NABCO ENTRANCES TECHNICAL BULLETIN

Improvements to Swinger Arms

Bulletin Number: **56**

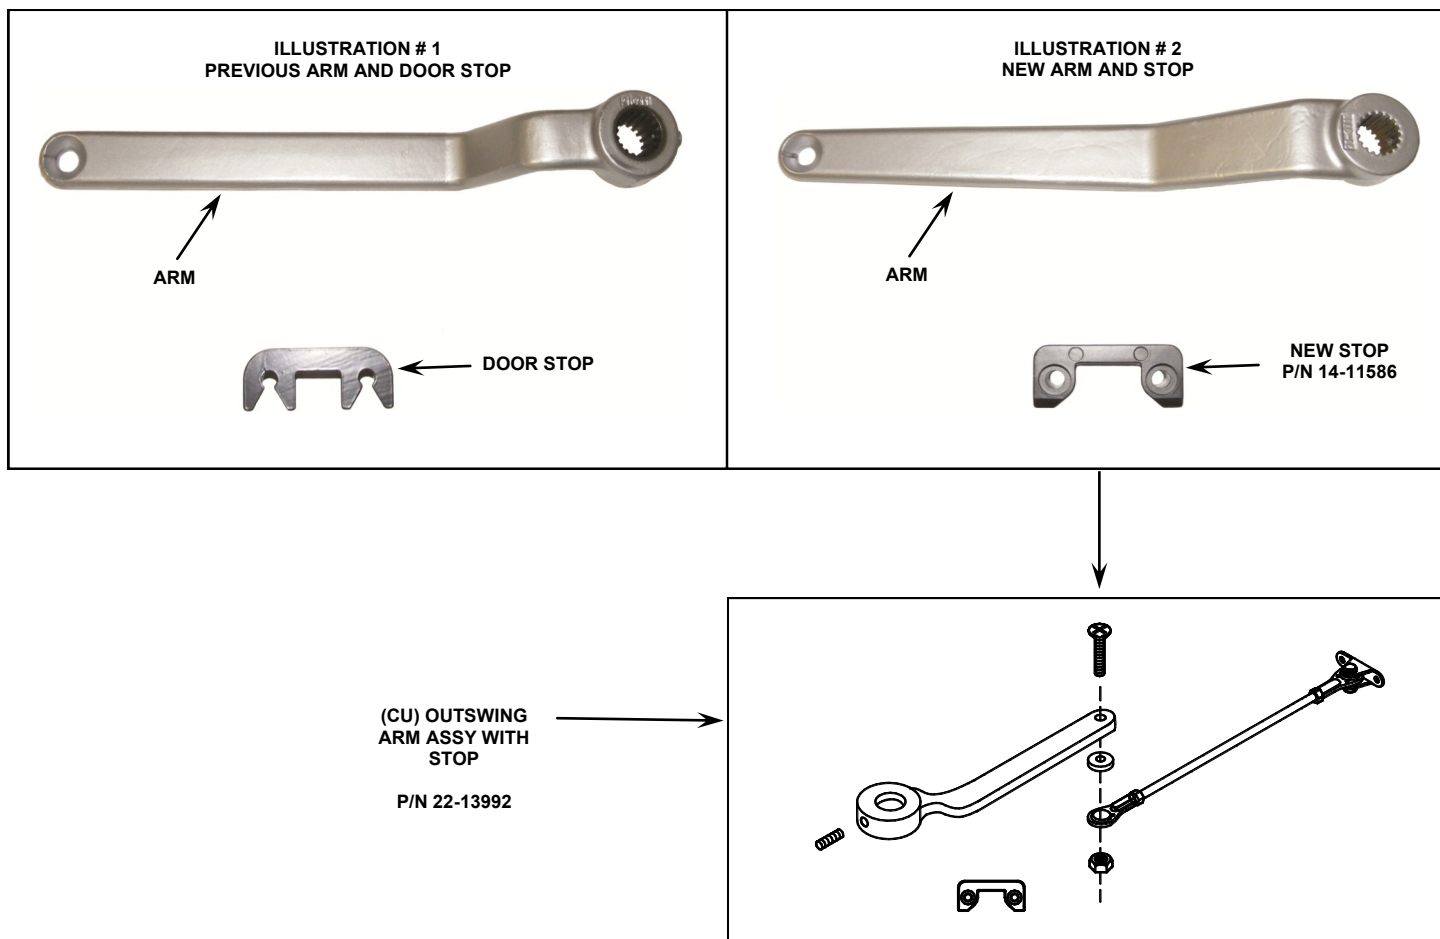
Following an ongoing product improvement program, we have made changes to the design of the GT 400/500/600 and GT 710 outswing arms and external stops. This change is effective immediately.

Refer to illustrations 1 and 2 below. Illustration # 1 shows the previous arm and stop and illustration # 2 shows the current arm and stop design. As can be seen in illustration # 2, the new arm is a strengthened design.

The new arm cannot be used with previous style stops. The new stop P/N 14-11586 may be purchased separately since it will accommodate previous outswing arm designs.

The new arm is available as assembly P/N 22-13992 as shown below.
